Torque Rod Replacement
CHU, CXU, GU, TD

FSB 652-004, Torque Rod Replacement

(February 2012)

W6070237

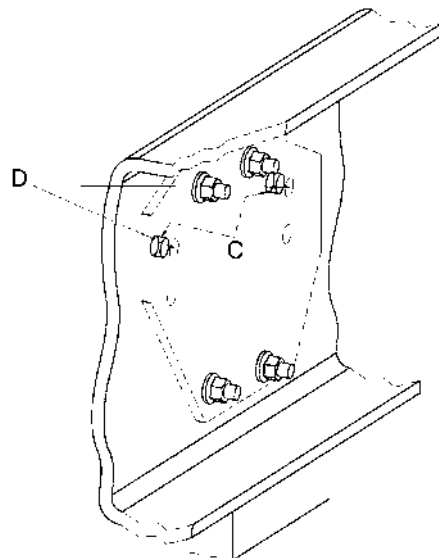
Assemble the new parts (inner and outer plates) onto the frame rail where the torque rod will be re-installed. Tighten the fasteners to 200 ± 30 Nm (148 ± 22 ft-lb).

W6070238

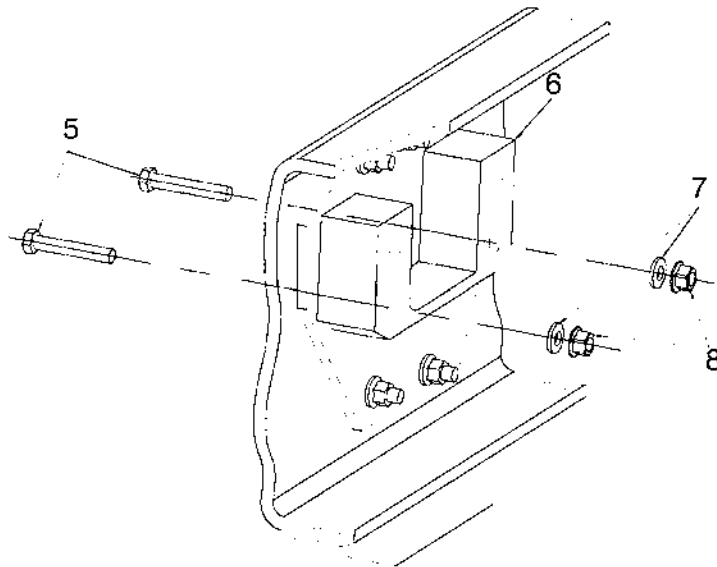
Note: Prior to drilling new holes in frame ensure that all six existing holes in frame line up with holes in new reinforcement plates. Then, use reinforcement plate holes "D" as guide to drill holes "C" in frame as directed below. Failure to do so will result in frame rail damage requiring frame rail replacement.

Drill two new 17 mm (0.67 in.) holes in the frame rail using the holes in the plate installed in the previous step as a guide.

W6070239

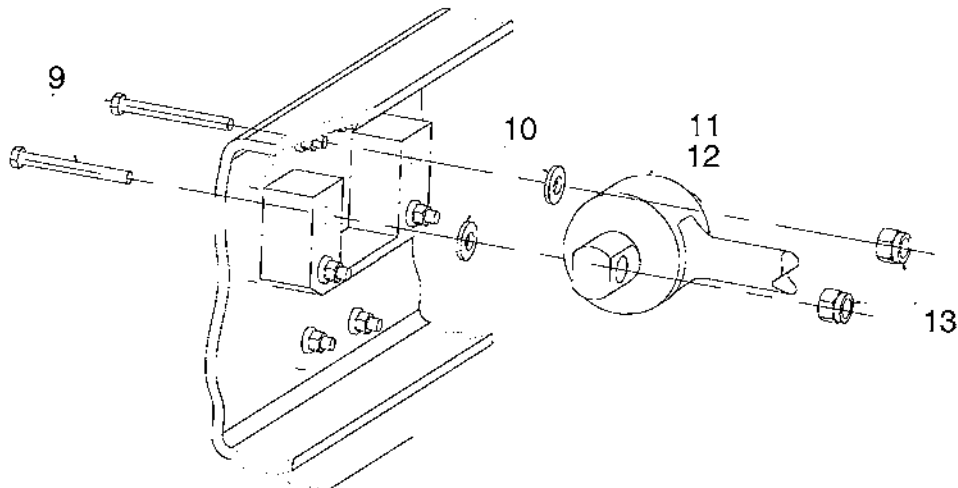
Install the new torque rod bracket and fasteners. Tighten the fasteners to 610–813 Nm (450 – 600 ft-lb).

W6070240

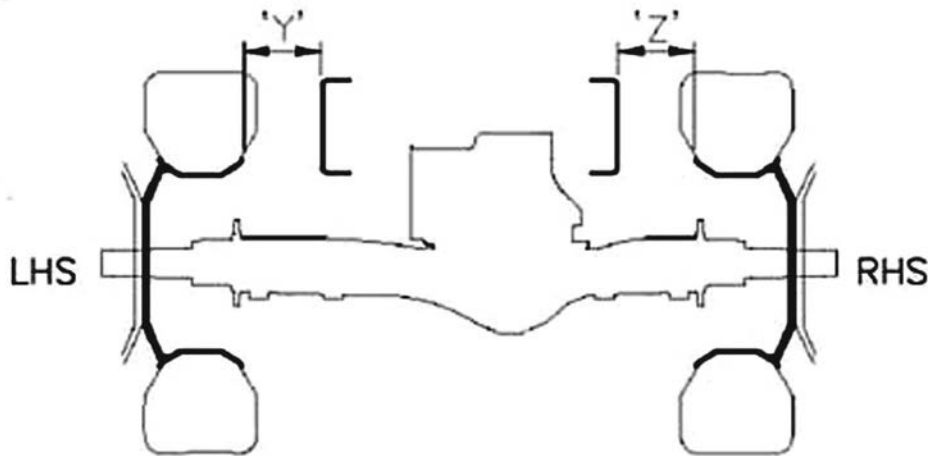
Connect the torque rod to the new holes on the frame rail torque rod bracket and tighten to specification 610–813 Nm (450 – 600 ft-lb).
